# METROPOLITAN GOVERNMENT OF NASHVILLE AND DAVIDSON COUNTY

## STAFF RECOMMENDATION

101 Broadway  
March 19, 2014

**Application:** Signage

Figure 1. Acme Farm Supply circa 1985

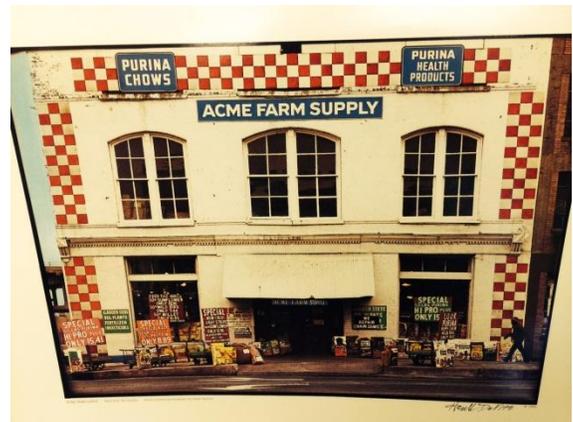
The project includes replacing a strip of molding above the front entrance that has been removed. The detailing of the proposed cornice closely resembles that which can be seen in a 1985 photograph; however, the material was not noted. With the condition that staff review the material, replacement of the missing feature meets section II.G.3 of the design guidelines.

- The projecting sign be located below the third-story window sills
- Staff review final materials of replacement moulding.

NORTH AND SOUTH ELEVATIONS

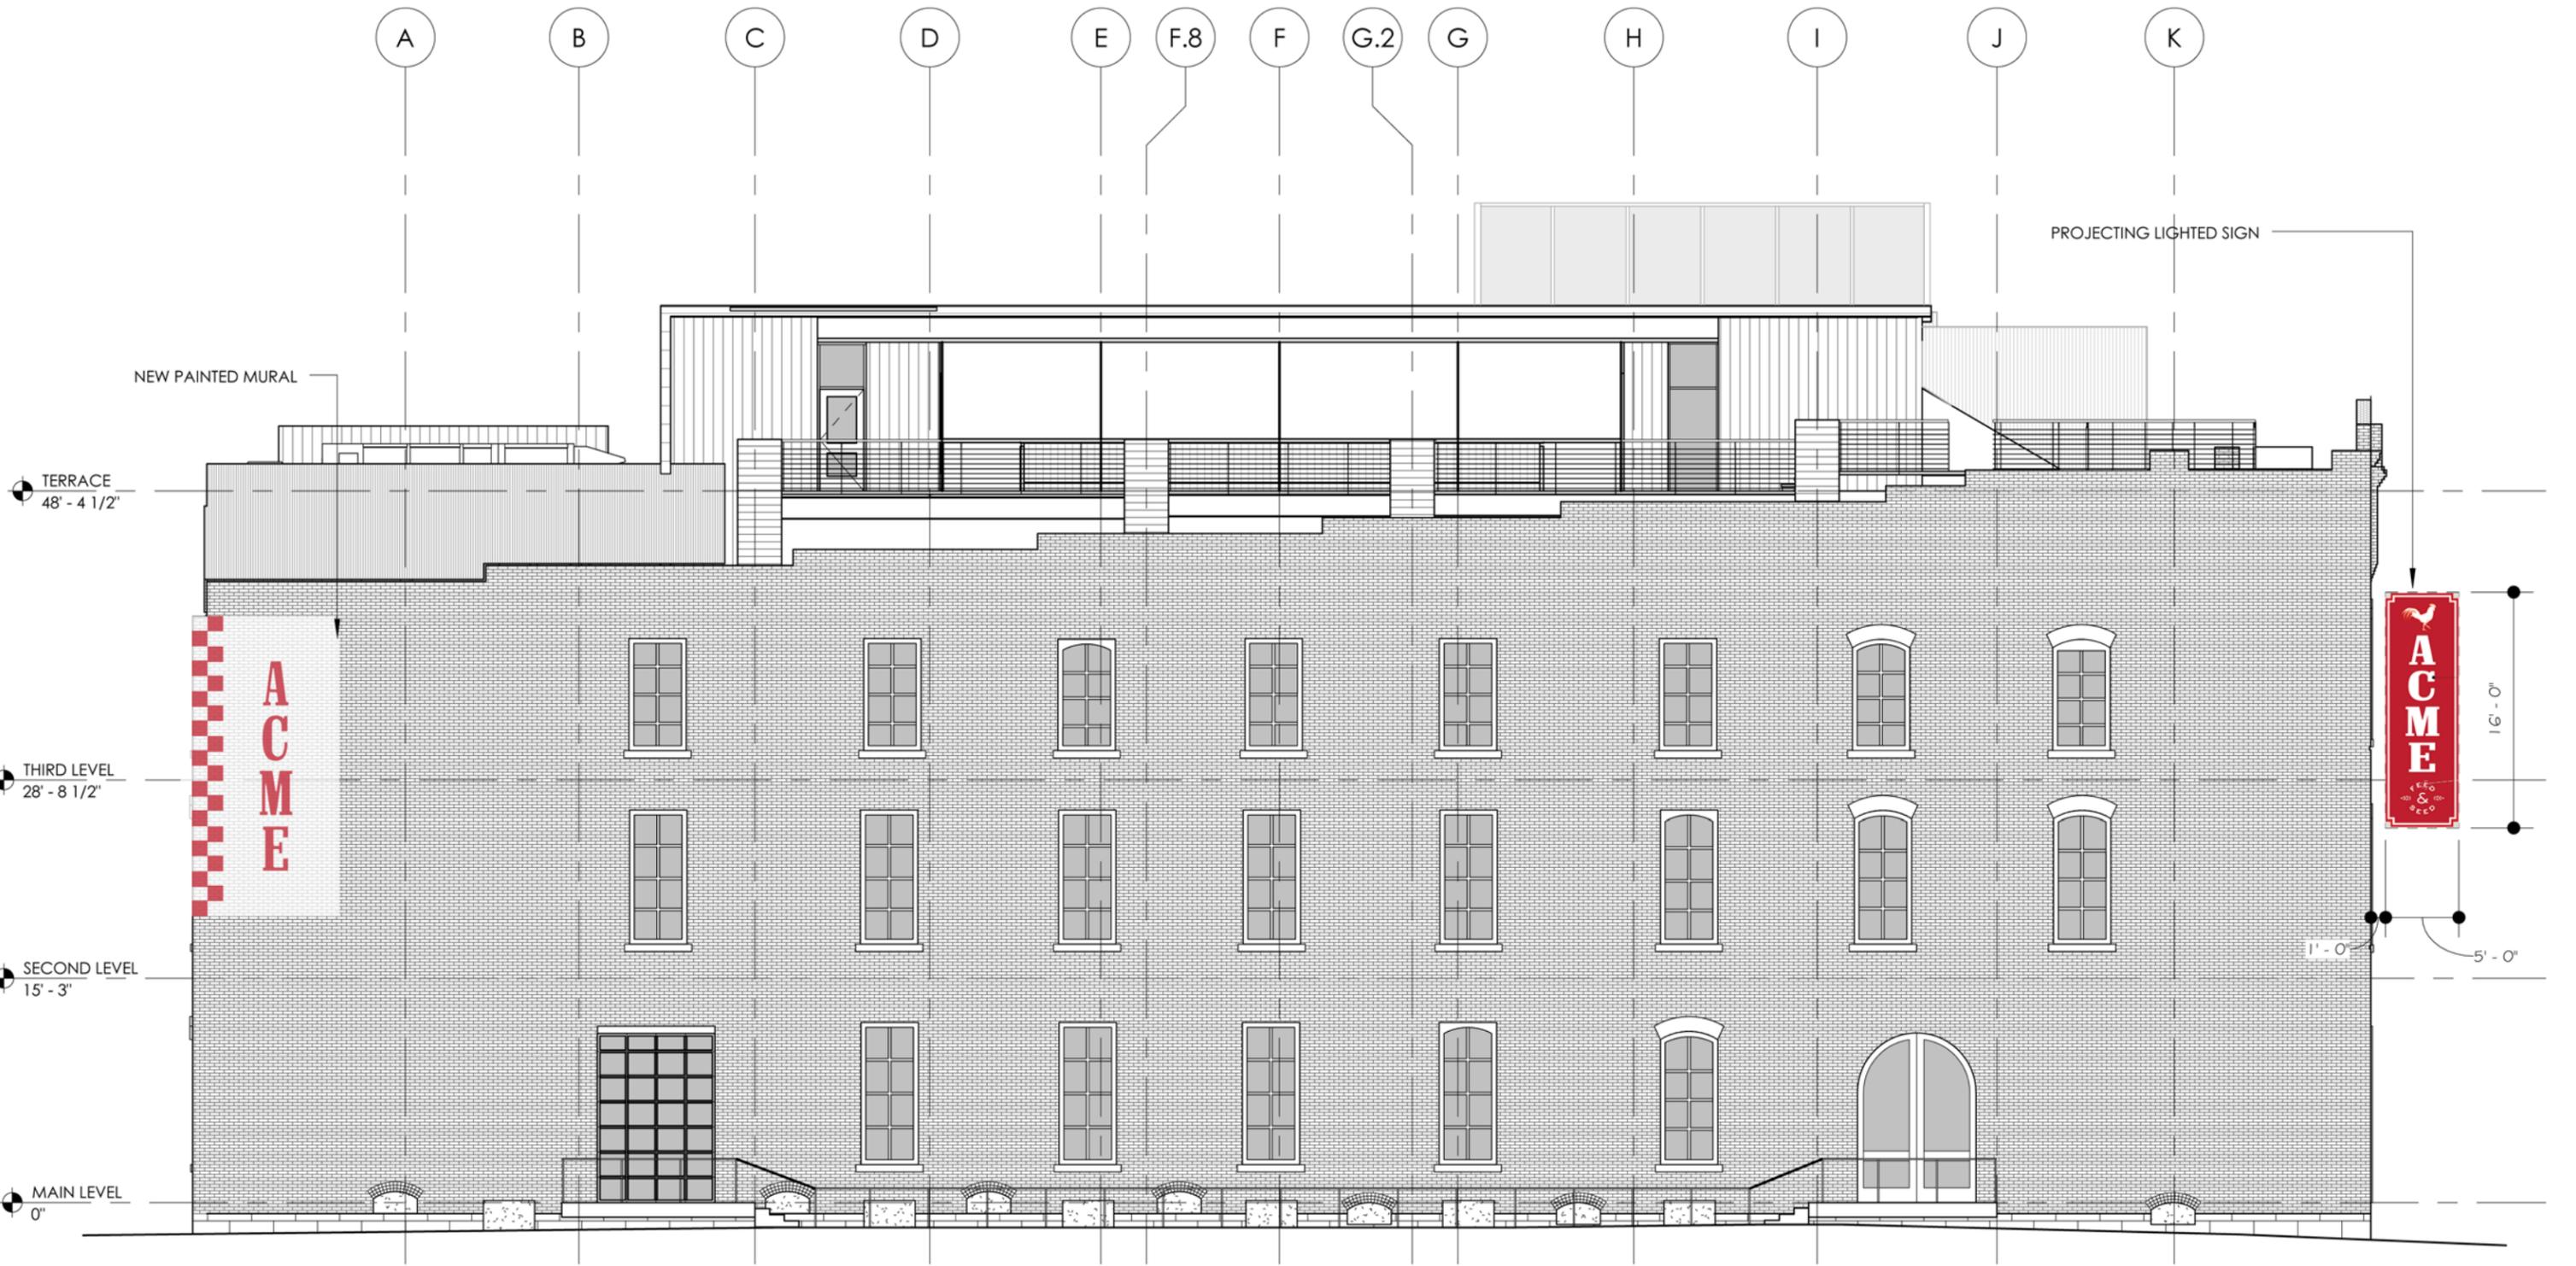
Location: In its current location it does not meet the design guidelines, which requires that projecting signs be located below the window sills of the third story. It is located at least twenty-five feet (25') from all other projecting signs, does not cover architectural details, and does not extend above the parapet, as required by the design guidelines. Staff recommends that the sign be located below the third-story window sills and not cover any architectural details. The vertical distance between the third-story window sills and the molding proposed is approximately sixteen feet (16'), leaving room for the sign to be relocated.

Design: A sixteen feet (16') tall sign is proposed, which meets the maximum height allowed by the design guidelines for a three-story building. The sign is proposed to be

one foot (1') from the wall and to have a width of five feet (5') with a total projection of six feet (6'), as required by the design guidelines. The depth of the cabinet is eighteen inches (18"), the maximum allowed for internally lighted signs.

EAST ELEVATION

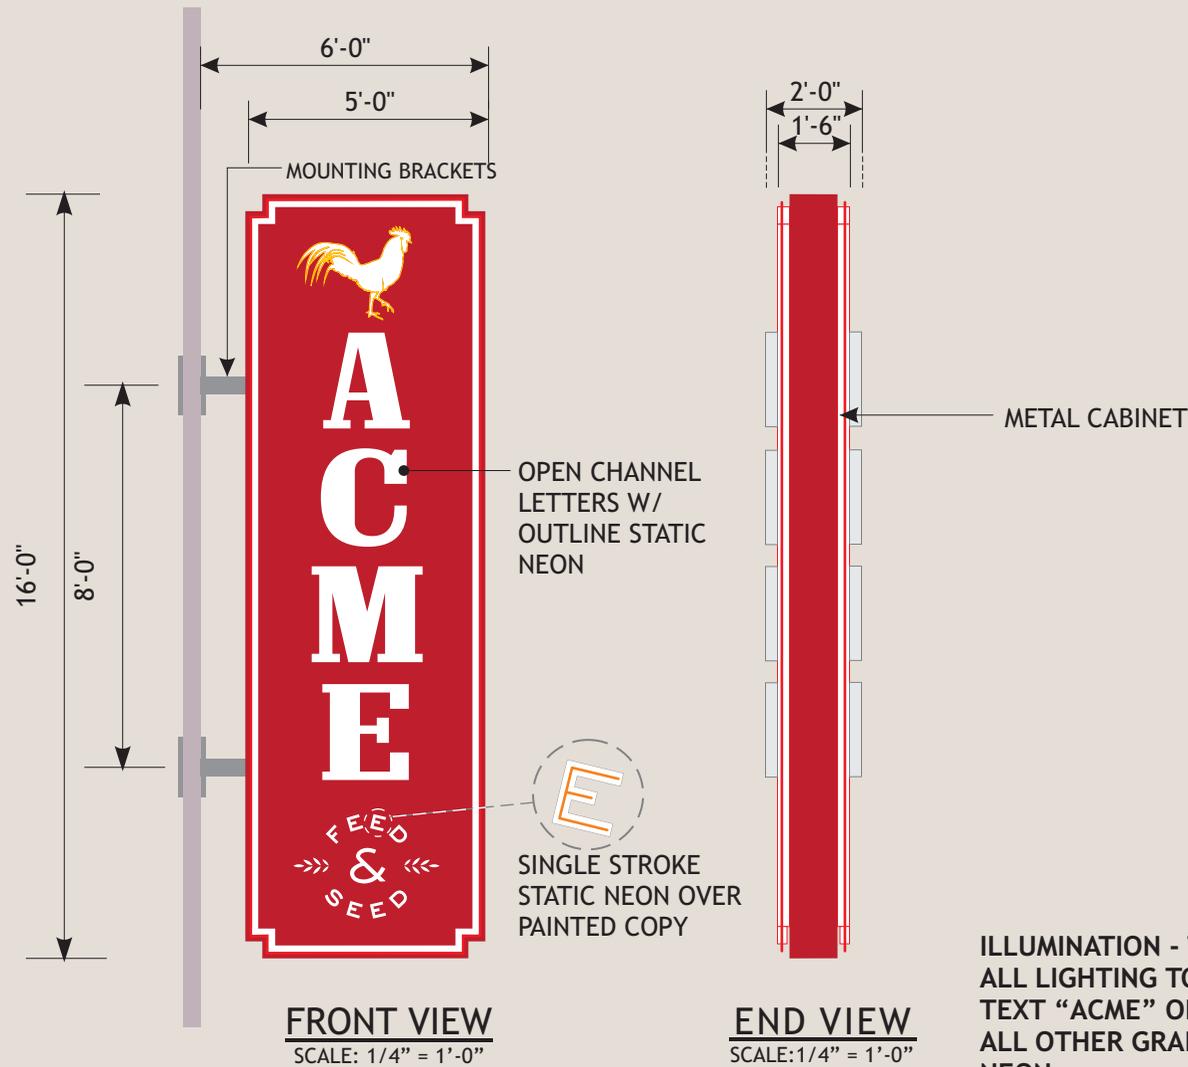
**Sign area for new painted sign:** The total area proposed for the painted sign on the First Avenue façade is two hundred square feet (200 sq.ft.). Design guidelines state that generally a painted sign should not be more than one hundred and twenty-five square feet (125'). Although the proposed painted sign is larger than design guidelines specify, Staff recommends approval of the sign given that this is a large building with a two large exposed facades. The content of the sign advertises the occupant, as required by design guidelines.

**Location for new painted sign:** Appropriate locations for painted signs include upper secondary elevations, which is the location of the proposed. The proposed sign does not cover transoms, columns, cornices, decorative elements, openings and architectural features or require the enclosure of openings. The location meets the design guidelines.
